Access Compliance Report

Public Rights-of-Way

Intersection ID: 30018	Main Street: W_MALLARD_CREEK_CHURCH_DR	Cross Street: BERKELEY_PLACE_DR	Location: NE
ADA ID: 1C441F0AB7D5	Ramp Type: Perp	Initial Pass/Fail: Fail	Overall Compliance: No
Severity Score: 22.5			
Codes/Mitigation Info/Possible Solution		Field Measurements/Component Compliance

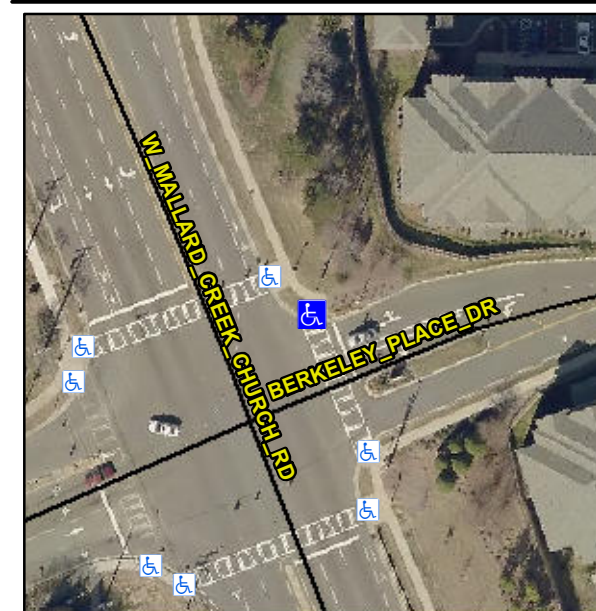
R304.5.1, R304.2.2, R304.5.3

Compliance	Description	Data	Compliance	Description	Data
N/A	Ramp Length (in)	85.0	No	Ramp Slope (%)	8.6
No	Ramp Width (in)	47.0	No	Ramp XSlope (%)	5.0
N/A	Flare Type LT	N/A	N/A	Flare Type RT	N/A
N/A	Flare Slope LT (%)	N/A	N/A	Flare Slope RT (%)	N/A
N/A	Flare Traversable LT?	N/A	N/A	Flare Traversable RT?	N/A
N/A	Landing Length (in)	N/A	N/A	DWS Provided?	N/A
N/A	Landing Width (in)	N/A	N/A	DWS Contrast?	N/A
N/A	Landing Slope (%)	N/A	N/A	DWS Length (in)	N/A
N/A	Landing X Slope (%)	N/A	N/A	DWS Full Width?	N/A
N/A	Landing Curb? (Y/N)	N/A	N/A	DWS Offset (in)	N/A
N/A	Shared Landing?	N/A			
N/A	Gutter Ponding?	N/A	N/A	Gutter Slope (%)	N/A
N/A	Gutter Lip Ht (in)	N/A	N/A	Gutter X Slope (%)	N/A
N/A	Painted X Walk1?	Yes	N/A	Painted X Walk2?	N/A
	X Walk 1 Direction	To S		X Walk 2 Direction	N/A
N/A	X Walk 1 Width (in)	115.0	N/A	X Walk 2 Width (in)	N/A
	X Walk 1 Slope (%)	1.7		X Walk 2 Slope (%)	N/A
	X Walk 1 X Slope (%)	4.3		X Walk 2 X Slope (%)	N/A

Remove & Replace Entire Ramp.
